From: Landon Chandler
Sent: Monday, March 23, 2020 8:13 AM
To: Kimberly Gibbons
Cc: rodneydent@yahoo.com
Subject: FW: [External]Fw: Xerox Scan
Attachments: CHOOCHOOHOMES Model (1).pdf; CHOOCHOOHOMES Model (1).pdf

Columbus Platt
154 Crepe Myrtle Ln
Erwin NC

From: Landon Chandler
Sent: Monday, March 23, 2020 3:05 PM
To: Kimberly Gibbons
Subject: RE: Color4618.pdf

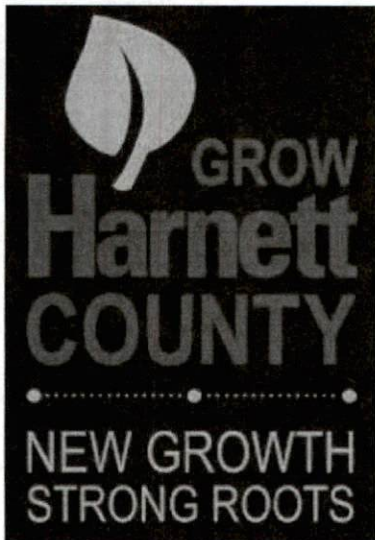
Based off the new survey showing the extent of the front porch, we can move forward with this application for 154 CREPE MYRTLE LANE. The new home will not be able to extend anymore forward or rearward from what the survey is showing. An as-built survey will be required to confirm this before CO. let me know if you have any questions.

His measurements will need to match the survey – ie, no less than 5.09' and 4.09' in the rear and 27.32' in the front.
